Regulation No. 117

**(UNIFORM PROVISIONS CONCERNING THE APPROVAL OF TYRES WITH REGARD TO
ROLLING SOUND EMISSIONS AND TO ADHESION ON WET SURFACES
AND TO ROLLING RESISTANCE)**

Proposal for draft amendments to Regulation No. 117- Rev. 1

Submitted by the expert from ETRTO

Example 2

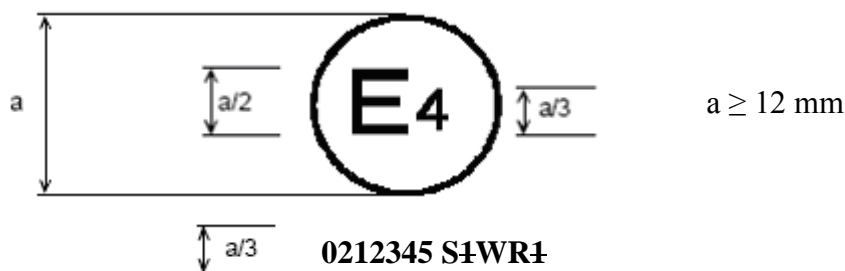
The above approval mark shows that the tyre concerned has been approved in the Netherlands (E4) pursuant to Regulation No. 117 (marked by ~~S1~~ (rolling sound at stage 1) W (wet adhesion), and ~~R1~~ (Rolling resistance at stage 1) under approval number 0212345. This indicates that the approval is for ~~S1WR1~~. The first two digits of the approval number (02) indicate that the approval was granted according to the requirements of the 02 series of amendments of this Regulation.

Example 1

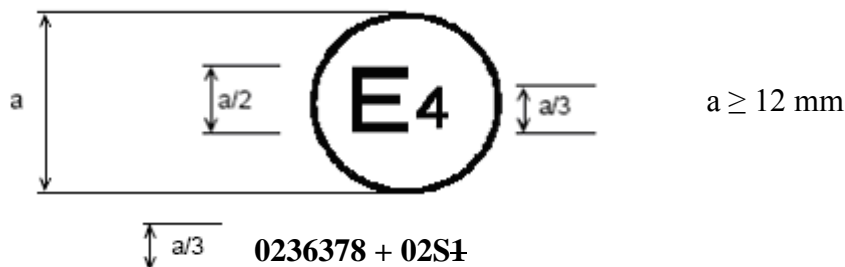
The above approval mark shows that the tyre concerned has been initially approved in the Netherlands (E4) pursuant to Regulation No. 30 and the 02 series of amendments under approval number 0236378. It is also marked by + 02~~S1~~ (rolling sound at stage 1) which indicates that its approval is extended under Regulation No. 117 (02 series of amendments). The first two digits of the approval number (02) indicate that the approval was granted according to Regulation No. 30 (02 series of amendments). The addition (+) sign indicates that the first approval was granted in accordance with Regulation No. 30 and has been extended to include the approval(s) granted according to Regulation No. 117 (02 series of amendments) for rolling sound at stage 1.

Example 2

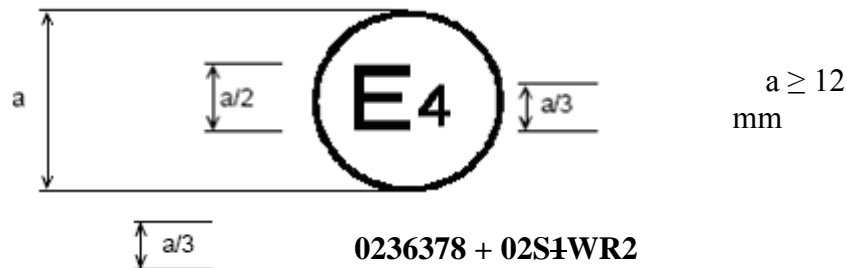
The above approval mark shows that the tyre concerned has been initially approved in the Netherlands (E4) pursuant to Regulation No. 30 and the 02 series of amendments under approval number 0236378. This indicates that the approval is for S1 (rolling sound at stage 1) W (wet adhesion) and R2 (rolling resistance at stage 2). The S1WR2 preceded by (02) indicates that it has had its approval extended under Regulation No. 117 which included the 02 series of amendments. The first two digits of the approval number (02) indicate that the approval was granted according to Regulation No. 30 (02 series of amendments). The addition (+) sign indicates that the first approval was granted in accordance with Regulation No. 30 and has been extended to include Regulation No. 117 approval(s) (02 series of amendments).

Example 1

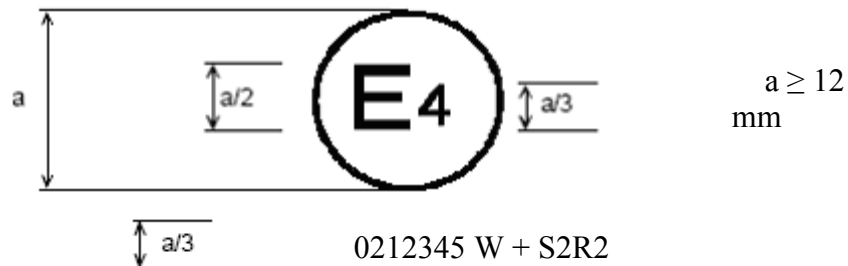
The above approval mark shows that the tyre concerned has been initially approved in the Netherlands (E4) pursuant to Regulation No. 117 and the 02 series of amendments under approval number 0212345. This indicates that the approval is for W (wet grip). The S2R2 preceded by + indicates that it has had its approval extended under Regulation No. 117 to rolling sound at stage 2 and rolling resistance at stage 2 based on separate certificate(s).

Example 2

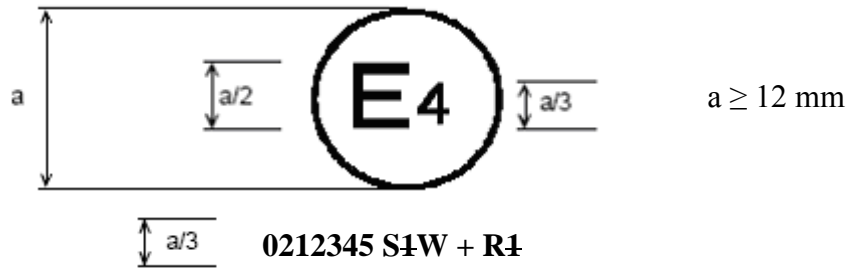
The above approval mark shows that the tyre concerned has been initially approved in the Netherlands (E4) pursuant to Regulation No. 117 and the 02 series of amendments under approval number 0212345. This indicates that the approval is for S1 (rolling sound at stage 1) and W (wet grip). The R1 preceded by + indicates that it has had its approval extended under Regulation No. 117 to rolling resistance at stage 1 based on separate certificate(s).

Example 3

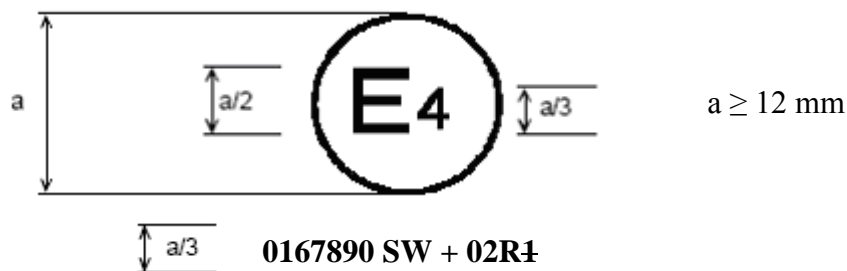
The above approval mark shows that the tyre concerned has been initially approved in the Netherlands (E4) pursuant to Regulation No. 117 and the 01 series of amendments under approval number 0167890. This indicates that the approval is for S (rolling sound at stage 1) and W (wet grip). The 02R1 preceded by + indicates that it has had its approval extended under Regulation No. 117 and the 02 series of amendments to rolling resistance at stage 1 based on separate certificate(s).
